Re: Drainage Plan Certification  
Lots 4, 5, 6, and 7, Tract 2  
Brentwood Park Addition

Re: REGARDING PLAN FOR LOTS 1-7, TRACT 2, LAWSON HEIGHTS

DRAINAGE COMMENTS

LOTS 1-7, TRACT 2, LAWSON HEIGHTS

TYPICAL LOT GRADING PLAN - LAWSON HEIGHTS FOURPLEXES  
 1" = 20'

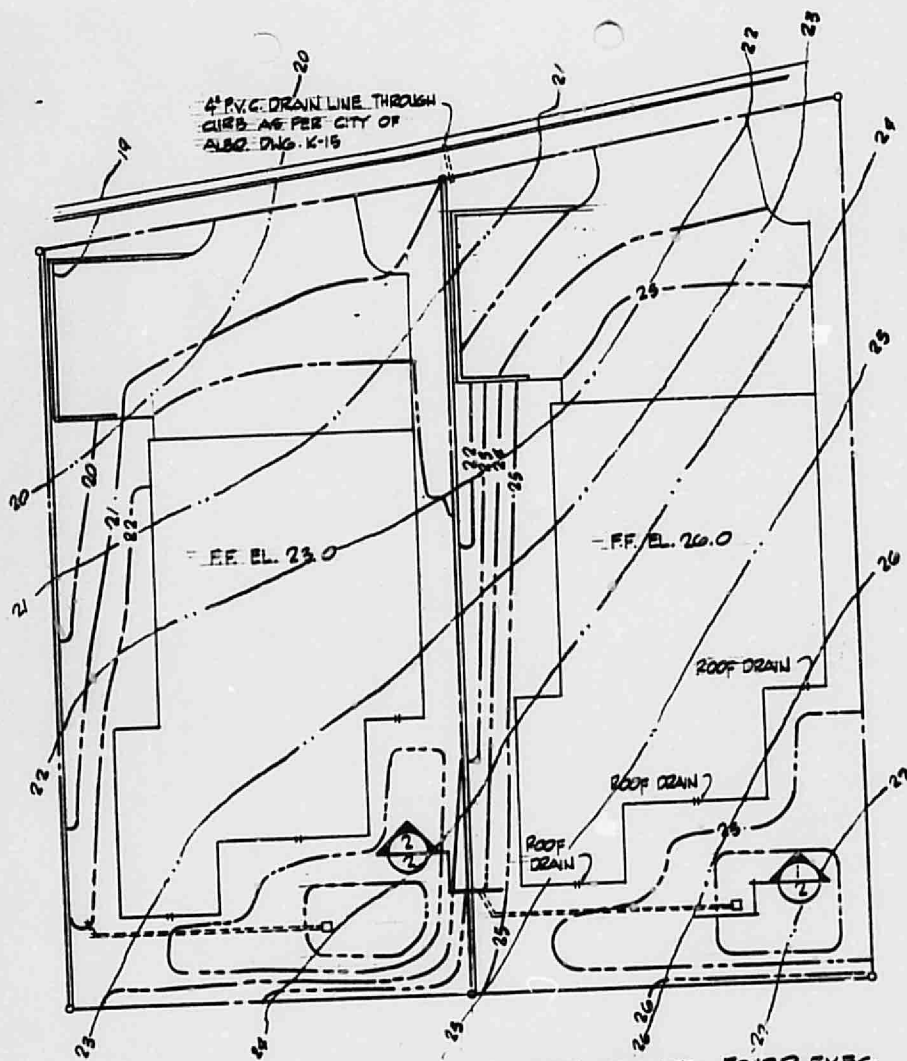
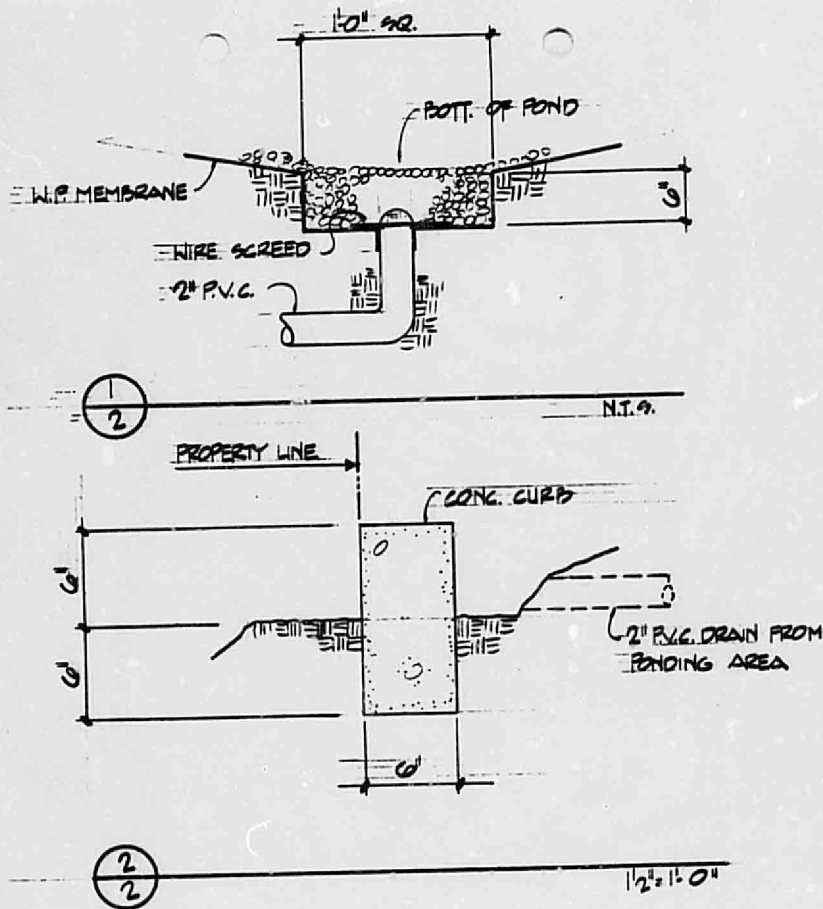
The sketches, Sheet No. 1 and 2 submitted for my review regarding the referenced development are consistent with the discussion that we previously had on the subject. Nevertheless, it seems to me that you may not be able to provide a consistent solution for this development without a completely revised site grading plan. The existing topography must also be shown, together with the proposed grading and it must be demonstrated that your proposal does not affect adversely the adjacent property to the south and to the east.
